**REPORT TO THE THIRTIETH LEGISLATURE
STATE OF HAWAII
2019**

**PURSUANT TO SECTION 342L-62 HAWAII REVISED STATUTES
THE THIRD ANNUAL FUEL TANK ADVISORY COMMITTEE MEETING
TO STUDY THE ISSUES RELATED TO LEAKS OF FIELD-CONSTRUCTED
UNDERGROUND STORAGE TANKS AT RED HILL BULK FUEL STORAGE FACILITY,
AND FOUR OTHER DOD FACILITIES**

**PREPARED BY:
STATE OF HAWAII
DEPARTMENT OF HEALTH
UNDERGROUND STORAGE TANK SECTION
JANUARY 2019**

Figure 1: Coupon No. 7 viewed from the cut edge shows the corrosion and staining on the backside against the concrete. Remaining wall appears to be about 2 mm or 0.079 inches.

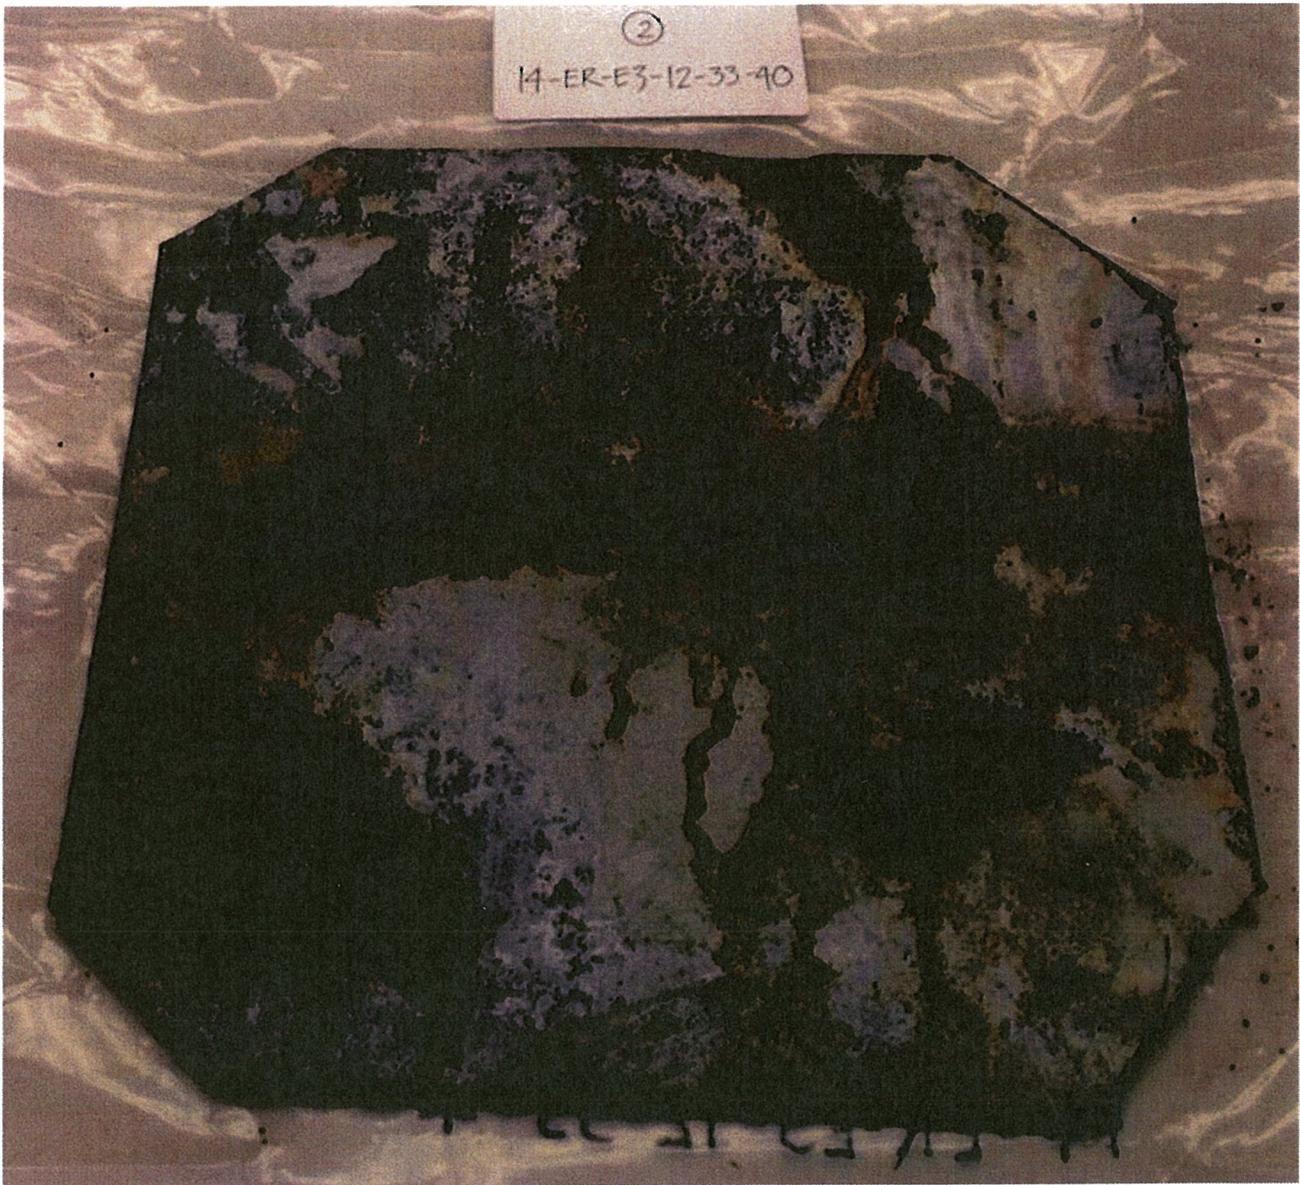
1. Presence of substantial backside corrosion — There were areas of substantial corrosion on the backside (non-fuel wetted side) of the ¼-inch thick steel plate lining the tank (Figure 1, for example).

remaining wall of 0.079-inches (see Figure 1). These are our observations, and we look forward to reviewing the results of the independent testing laboratory for confirmation.

NDE remaining thickness: 0.135" to 0.187"
Apparent remaining thickness: 2mm = 0.079"

Figure 2: Backside of Coupon No 2 – The dark horizontal stain is likely corrosion product and/or hydrocarbon stains. Drip seen running down backside.

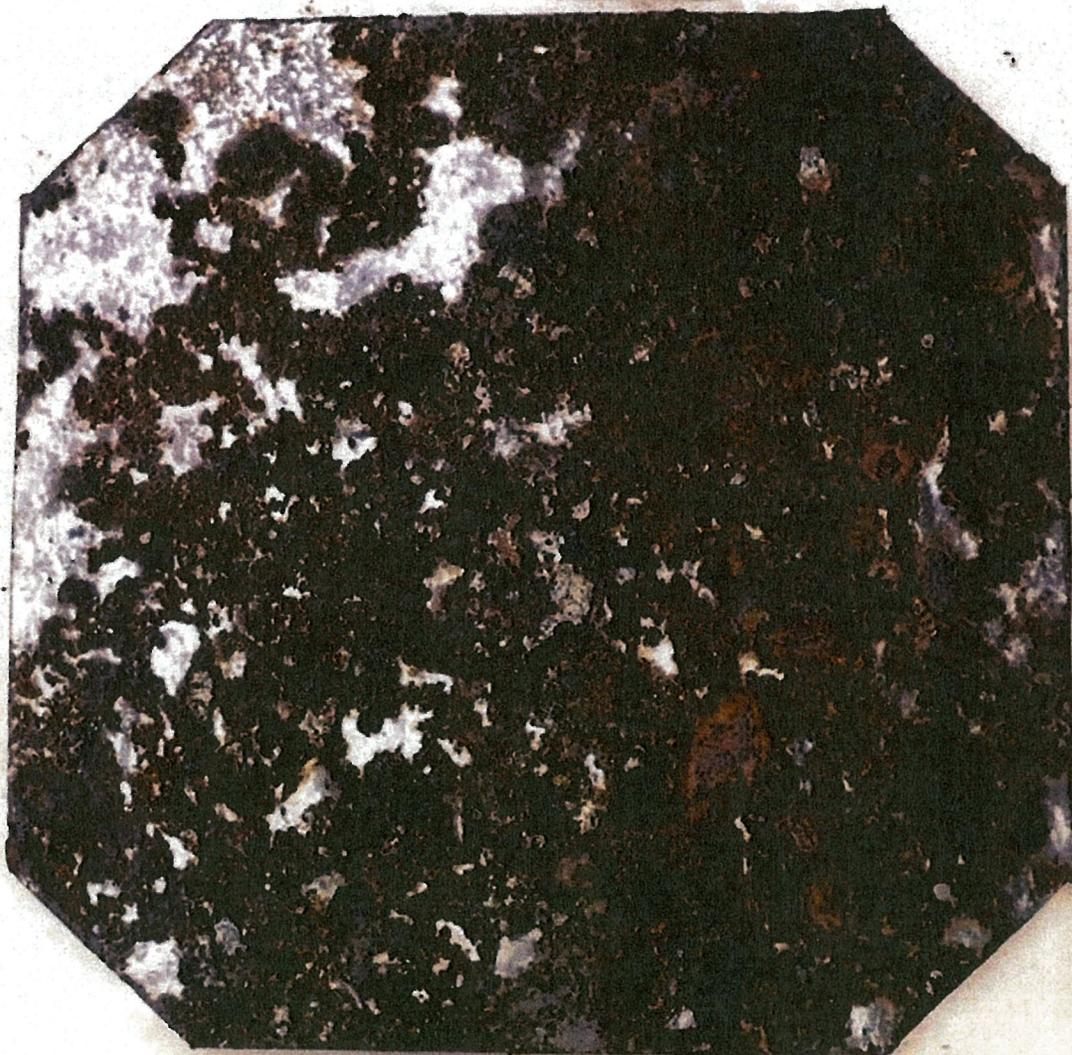
2. Staining on Backside of Steel — Deposits on the backside of some coupons suggest hydrocarbon-staining and should be tested for presence of released product (Figure 2, for example).
3. Non-Destructive Evaluation (NDE) Technique Underestimates Remaining Wall Thickness — Corrosion pit depths measured on the cut specimen edges suggest that NDE techniques were not able to locate and measure the thinnest wall of the coupon. For instance, the scale shown in Figure 1 indicates the wall along the edge of Coupon No. 2 has thinned to about 0.079-inches (reduced from 0.25-inches thick when new). However, the two NDE techniques (screening and Prove-up) predicted the thinnest area of this coupon to be 0.187-inches and 0.135-inches, respectively, underestimating the measured thickness by 51%.
